4410-86-L-0173
Document ID 0113P

September 26, 1986

Three Mile Island Nuclear Station, Unit 2 (TMI-2)
Operating License No. DPR-73
Docket No. 50-320
Deep-Bed Filters In The DWCS

**CONCEPTUAL ARRANGEMENT FOR
CONVERSION OF "KNOCK-OUT" CANISTER
TO A D.E. FILTER WHICH CAN BE USED
TO CLEAN UP POOLS & RV**

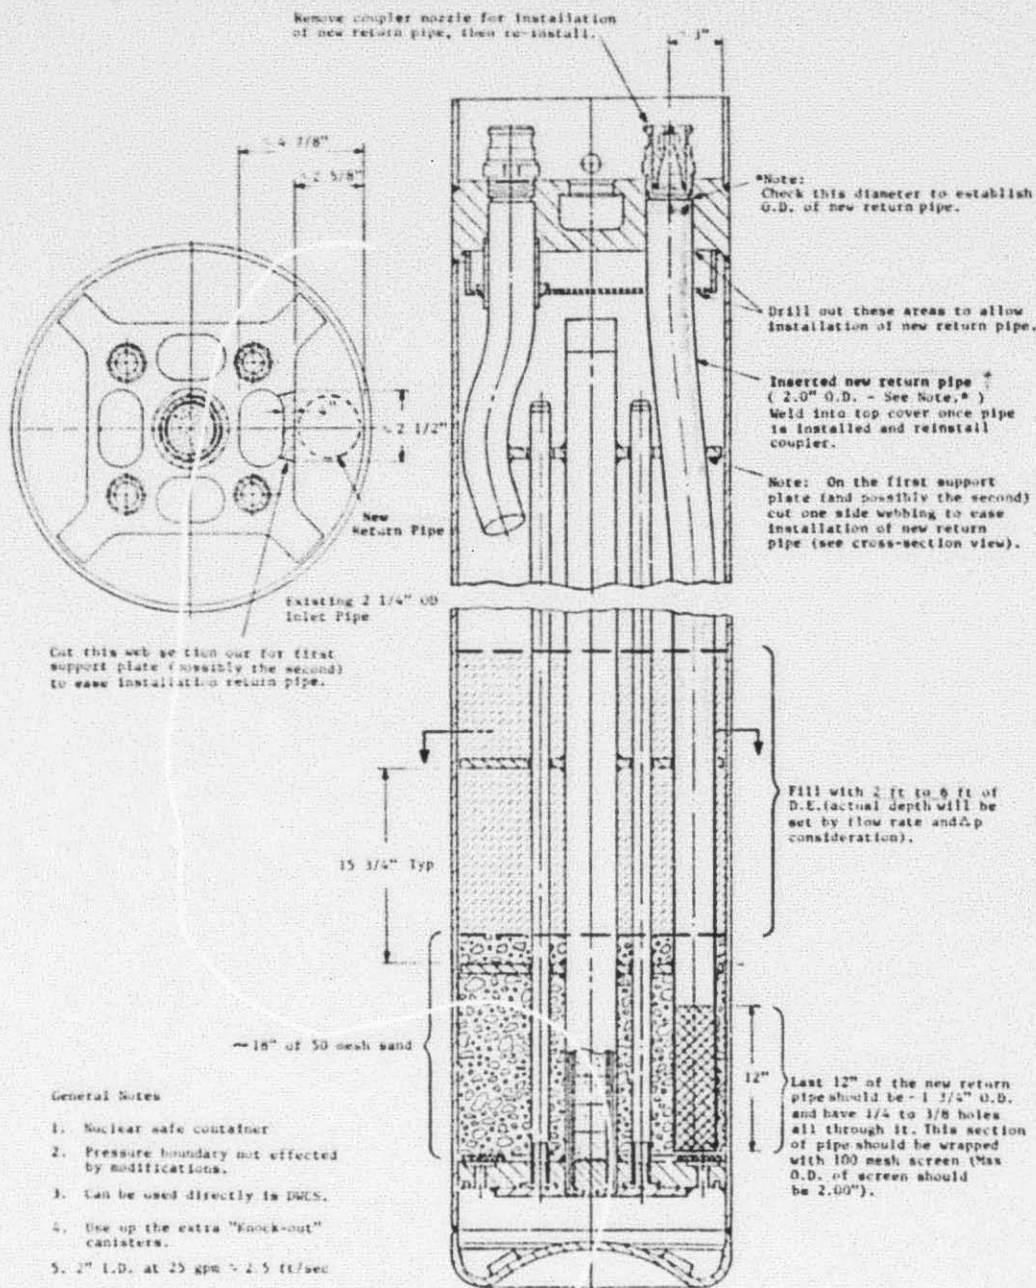
- o Cutting the existing inlet tube below the support ring,
- o Adding a 2" O.D. stainless steel pipe as an outlet tube,
- o Routing the outlet tube through the gap between two legs of the support spiders,
- o Sizing the support ring to accommodate the outlet tube, and
- o Extending the outlet tube down to within 1" of the bottom plate.

The bottom 12" of the extended outlet tube will have multiple 1/4" to 3/8" holes and will be covered with a 100 mesh stainless steel screen. The outlet tube will be attached to one (1) or more support spiders to prevent significant motion of the outlet tube during canister handling. These minor modifications are expected to have no adverse impact on the previous structural evaluations performed on the knock-out canisters. The canister designer is currently reviewing these modifications to confirm this. GPU Nuclear will inform you if any significant deviations to the previous structural evaluations are discovered.
